Wylfa Newydd Project

Request for Non-Material Change (RfNMC) no.6

Dalar Hir Park and Ride Junction Improvement

PINS Reference Number: EN010007

Appendix A Drawing P 60506637/SK/54 Showing the Revised Junction Layout

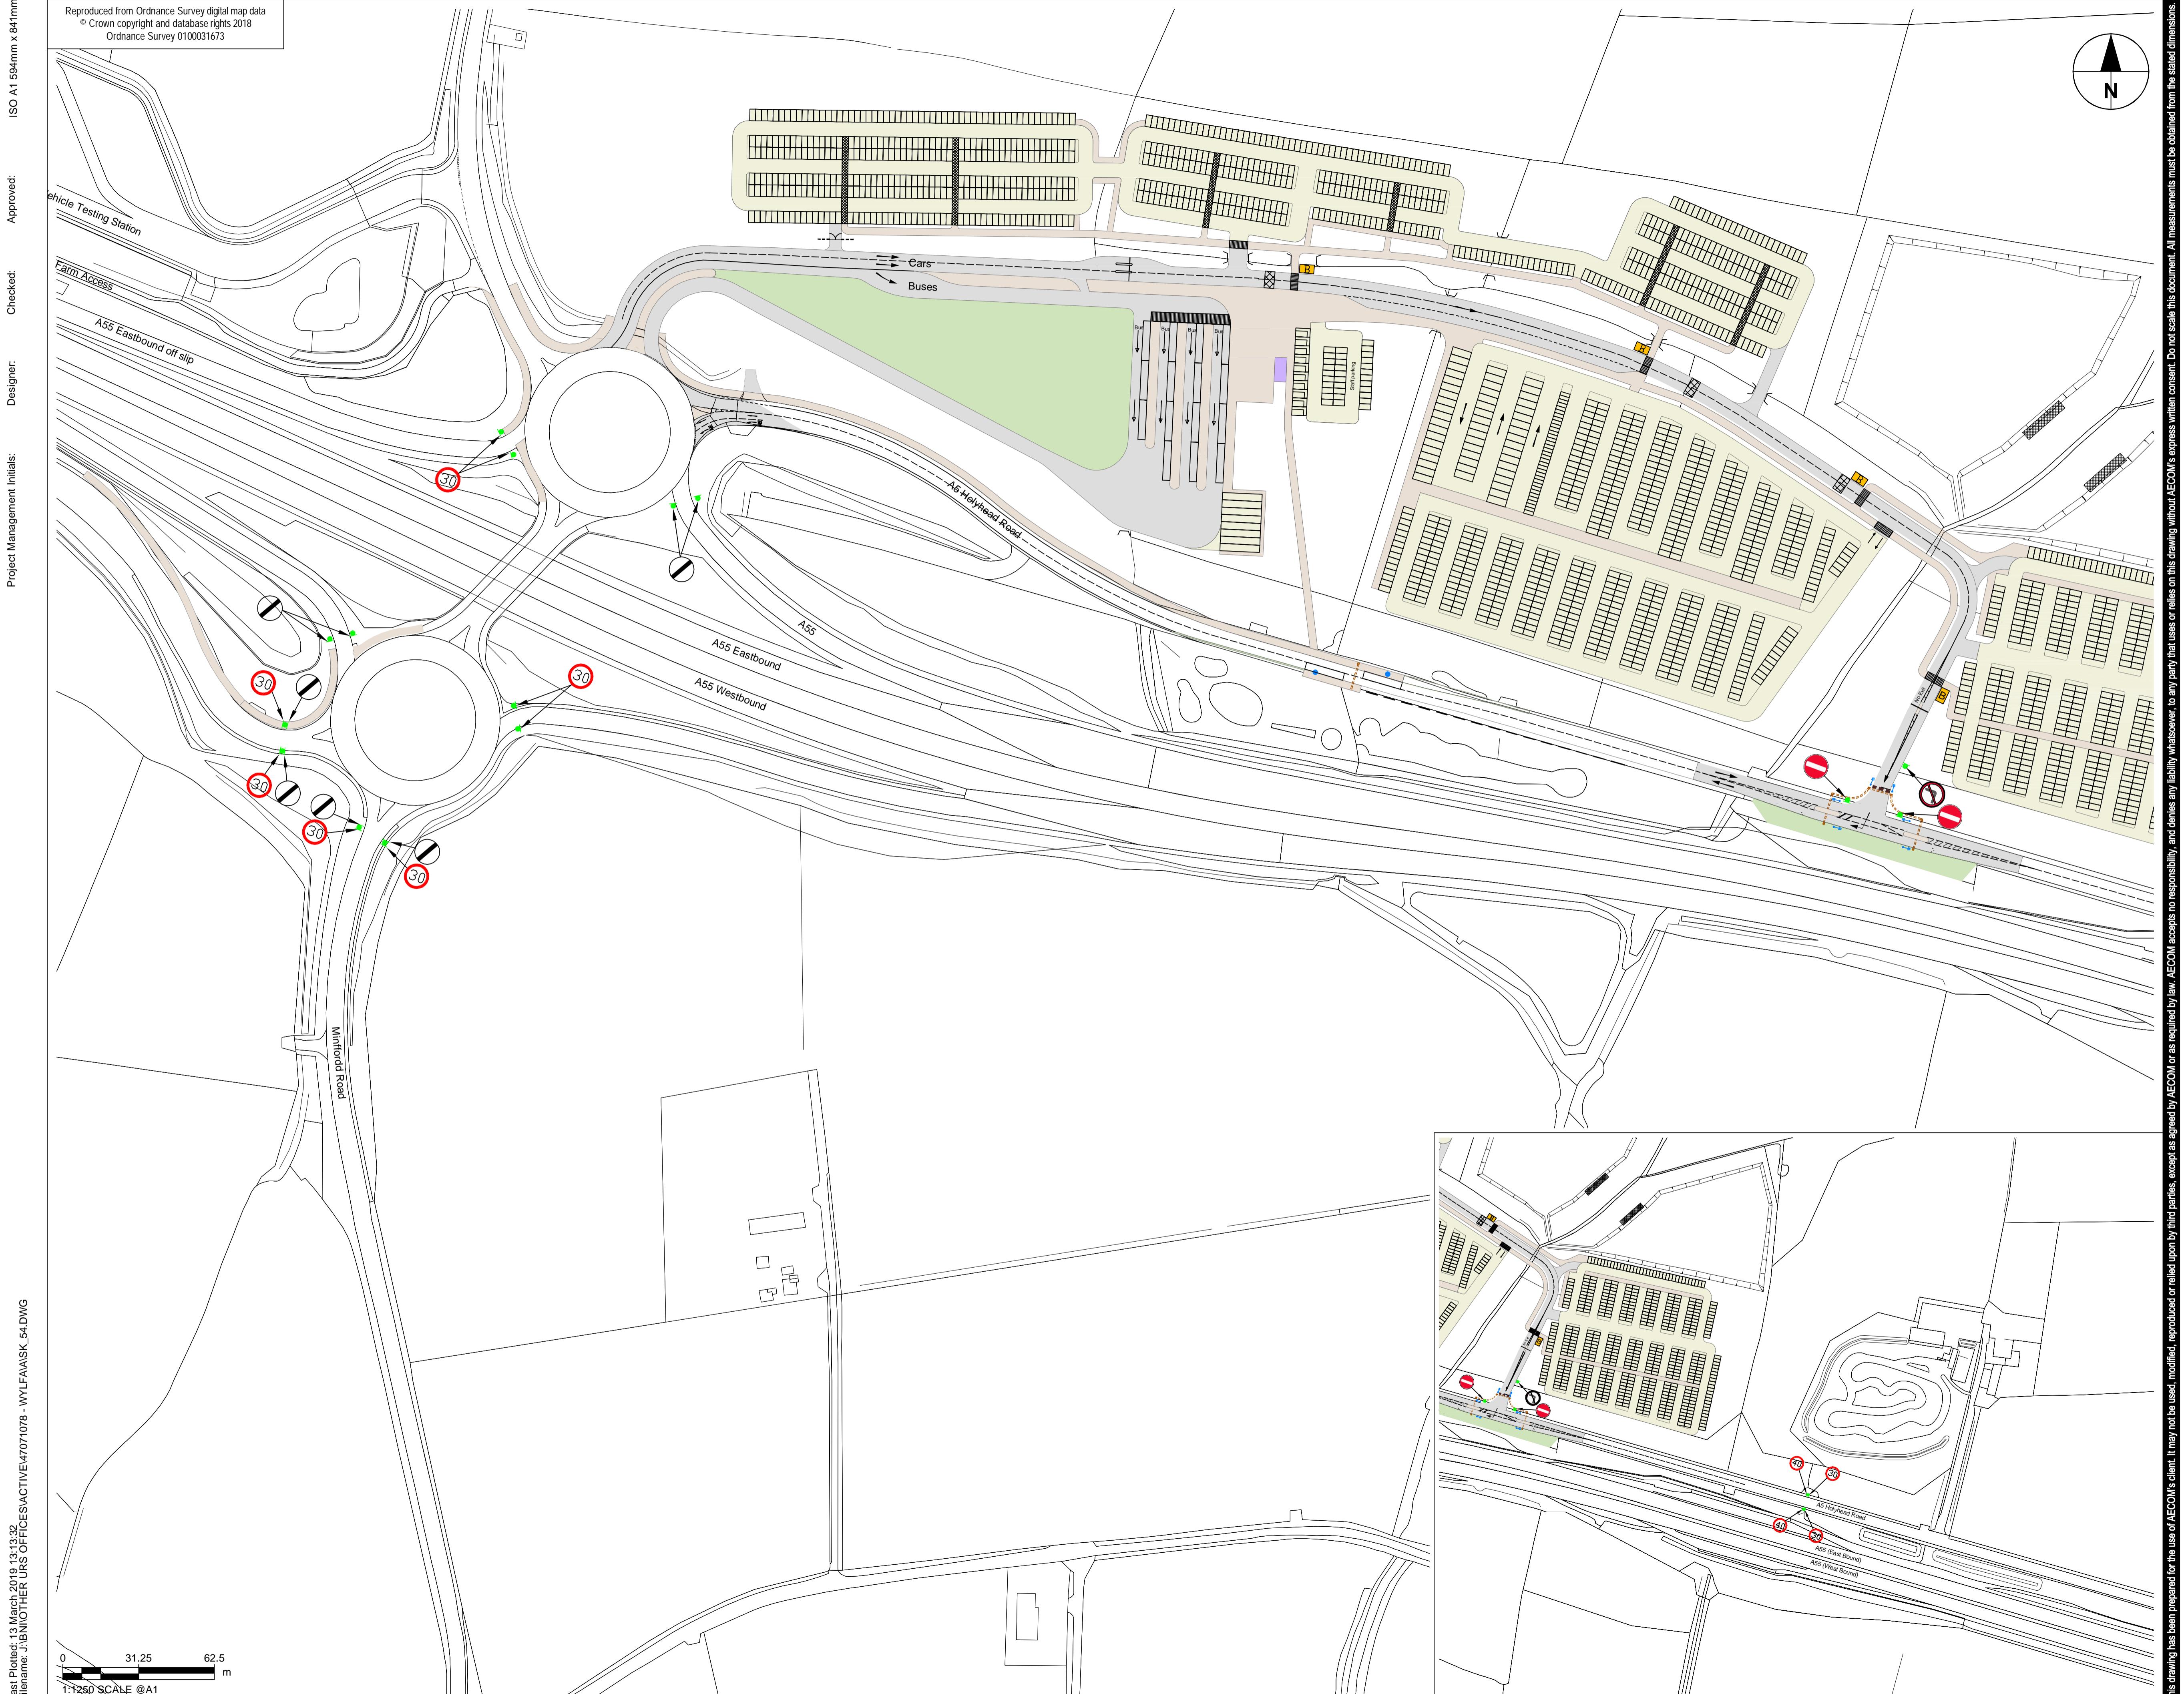
- 1.1.4 The non-material change proposed is to remove the internal roundabout at the Park and Ride, and instead to provide a single arm from the existing A5 roundabout at the A5/A55 dumbbell junction (Junction 4), as described in section 2.4 and shown in plan P 60506637/SK/54 in Appendix A. The change is proposed in order to improve junction safety and has the full support of IACC as the local highway authority. No new or different likely significant environmental effects are predicted in relation to the proposed change.

- 2.3.1 The additional leg (as shown on drawing P 60506637/SK/54 in Appendix A) provided on the north edge of the existing 70m ICD roundabout has been designed in accordance with DMRB TD16 standards. The main geometric details are as follows:
 - Carriageway centreline radius – 27.5m – this is commensurate with typical development-type roads rather than main or distributor-type roads and reinforces low speed nature of site.
 - Entry Width – 6.0m – to be marked as a single lane entry on to the roundabout for buses only; this is a continuation of the road width provided on site.
 - Entry radius – 20m – this is the desirable value entry radius for large vehicle provision in rural areas.

- Entry path curvature / deflection – circa 28m – the low centreline approach radius ensures that speeds will be low on approach and that compliance with 100m maximum is easily achieved.
- Exit width – 9.5m – this provides for separate exiting of the roundabout for public and dedicated bus traffic and is in keeping with the existing circulatory width of 10m.
- Exit radius – 20m – this is at the lower end of recommended radii but a ‘fast’ exit is not required due to low speeds within the site.
- Visibility – visibility commensurate with vehicle speeds will be available across the footpath and verge areas.

2.3.2 The land previously occupied by the deleted roundabout that is not part of the revised road layout will be incorporated into the soft landscape.

2.3.3 The existing carriageway has been widened in the vicinity of the roundabout to provide a short length (around 30m) of two-lane approach, while minimising the impact on existing features. The main geometric details are as follows:

- Carriageway centreline radius – 163m – as existing.
- Entry Width – 8.3m – to be marked as a two-lane entry on to the roundabout, left lane to A55 east (predominant flow from site) and right lane for all other movements.

- Entry radius – 20m – this is the desirable value entry radius for large vehicle provision in rural areas.
- Entry path curvature / deflection – circa 50m – the proposed changes increase the radius slightly but it is still much lower than the 100m maximum.

- Exit width – 7.0m – this is the recommended width for a normal roundabout exit and slightly larger than the existing width of 6.5m.
- Exit radius – 40m – this is the recommended radius for an exit from a roundabout of this nature.

- Visibility – the proposed changes will move the object point to a more favourable location than existing and will therefore improve existing approach visibility which appears to be around 160m, this being commensurate with an 85kph design speed.
